**Subject: Beaver Valley Power Station, Unit No. 1
BV-1 Docket No. 50-334, License No. DPR-66
Response to Information Request Dated June 8, 1993
Spent Fuel Pool Rerack
(TAC No. M84673)**

This letter provides a response to your request for additional information regarding our proposed Technical Specification Change Request No. 202, submitted by letter dated November 2, 1992. These concerns are related to the seismic analyses that were performed to rerack the spent fuel pool. Attachment A provides each item followed by our response.

Beaver Valley Power Station, Unit No. 1
Response to Information Request Dated June 8, 1993
Spent Fuel Pool Rerack

FIGURE 9 BEAM LOADING

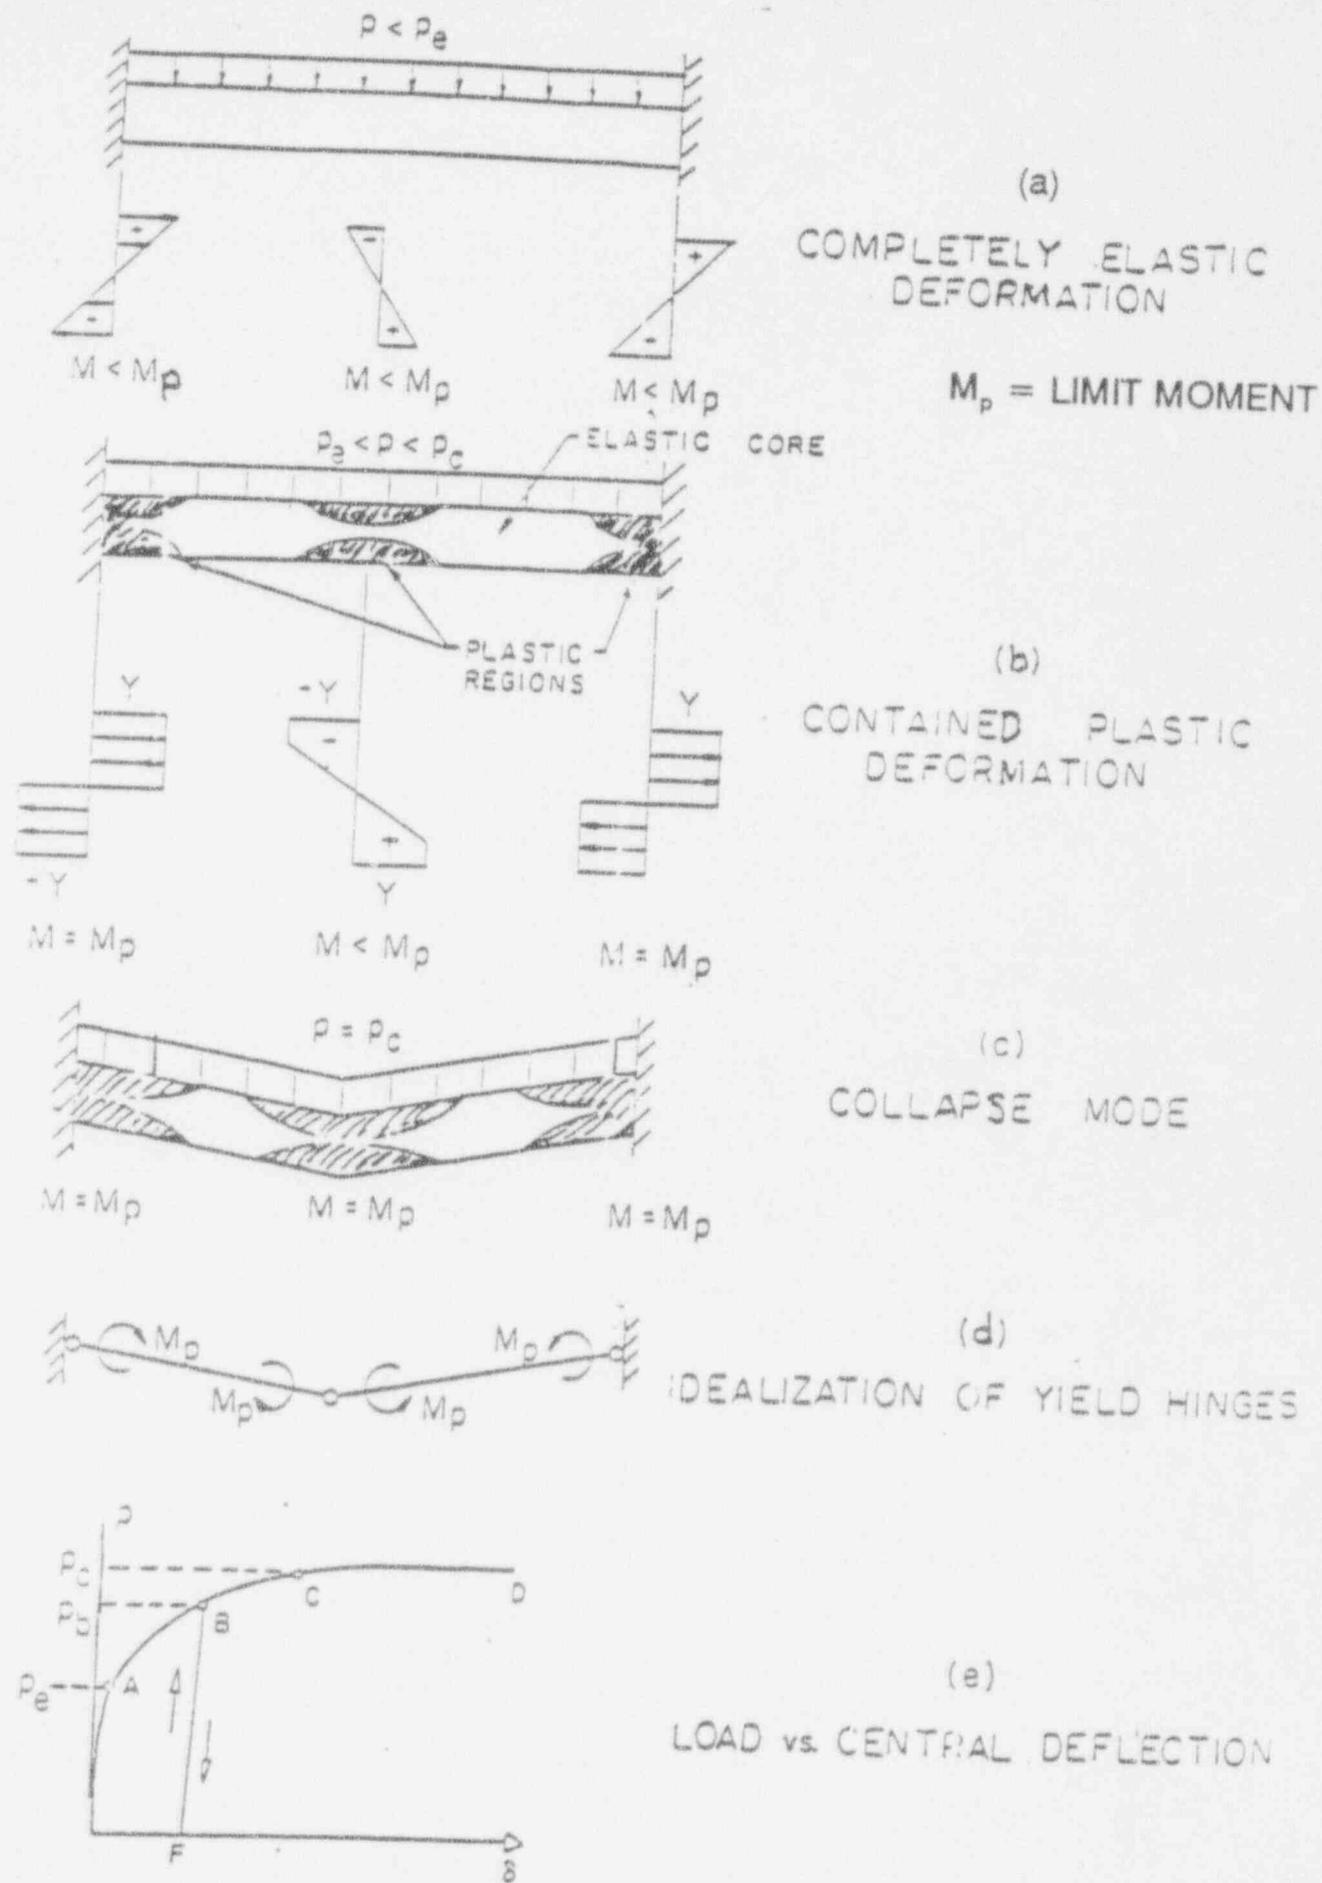
On page 6-27 it is stated that, "Local cell wall integrity is conservatively estimated from peak impact loads. Plastic analysis is used to obtain the limiting impact load." Should the word "limiting" be replaced by "peak"? Describe the procedures of this plastic analysis that were used to obtain the limiting, or peak, impact load.

The limiting impact load that can be supported is determined by modeling a strip of cell wall which is in contact (during an impact) with the fuel assembly at a given location. The limiting impact load is that load which when exceeded will lead to large deformations under any further increase in load. Figure 9 sequentially shows the calculation applied to a clamped beam under a uniform load. The factor p_c times the length of the beam is the collapse load in this case, p_{CL} must be greater than the corresponding peak load calculated from the dynamic event. Figure 9 shows the configuration for a uniformly loaded strip for illustrative purposes only; the limit load calculation for fuel assembly-cell wall impact is based on two concentrated forces applied to the beam strip at the fuel cell/fuel assembly contact locations subsequent to the impact.
